REVISION B CONSTRUCTION DETAILS

MARYLAND DEPARTMENT OF TRANSPORTATION
STATE HIGHWAY ADMINISTRATION - OFFICE OF TRAFFIC
BUREAU OF TRAFFIC ENGINEERING

MD 214@ LAKE ARBOR WAY & KETTERING DRIVE

TS/FILE NO. TS 1896 B

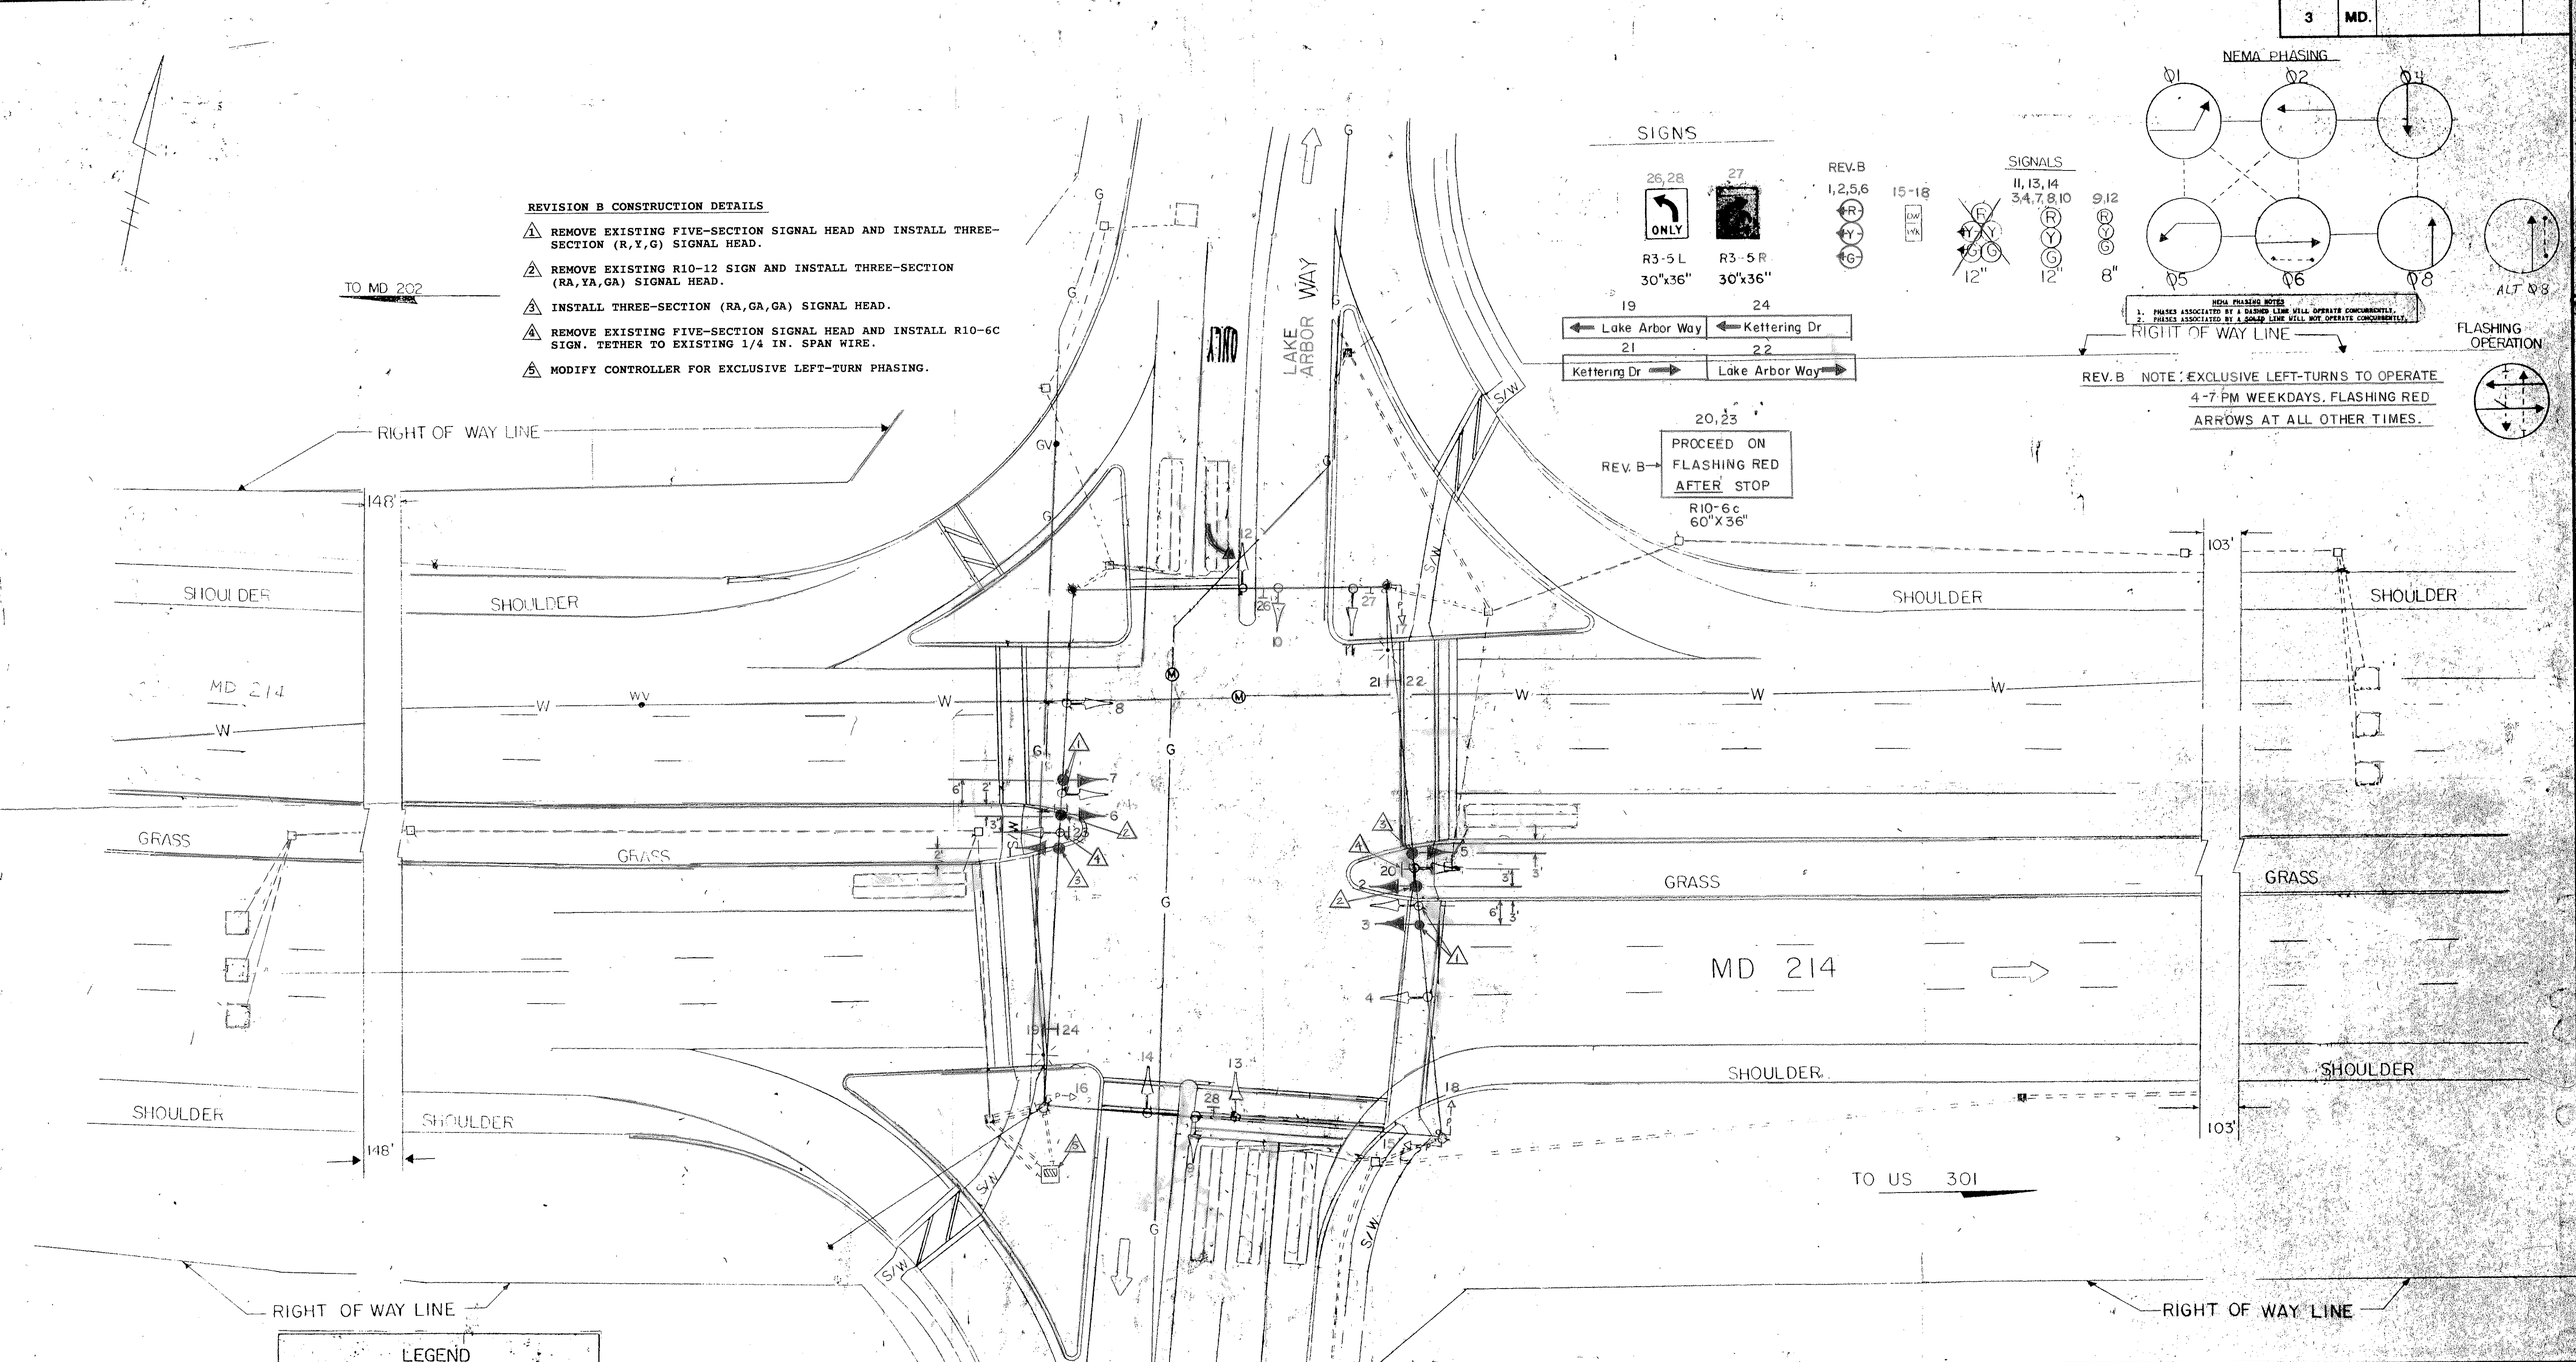
1. REMOVE EXISTING FIVE-SECTION SIGNAL HEAD AND INSTALL THREE-SECTION (R,Y,G) SIGNAL HEAD.
2. REMOVE EXISTING R10-12 SIGN AND INSTALL THREE-SECTION (RA,YA,GA) SIGNAL HEAD.
3. INSTALL THREE-SECTION (RA,GA,GA) SIGNAL HEAD.
4. REMOVE EXISTING FIVE-SECTION SIGNAL HEAD AND INSTALL R10-6C SIGN. TETHER TO EXISTING 1/4 IN. SPAN WIRE.
5. MODIFY CONTROLLER FOR EXCLUSIVE LEFT-TURN PHASING.

REVISIONS	APPROVALS
1 11-8-95 CHANGE E/P LTS TO EXCL. AND FL/R ARROWS. DJD	CHIEF, SIGNAL DESIGN SECTION
	ASST. DISTRICT ENGINEER, TRAFFIC
	CHIEF, BUREAU OF TRAFFIC ENGINEERING 12-5-86
	DEPUTY CHIEF ENGINEER, OFFICE OF TRAFFIC 12-5-86
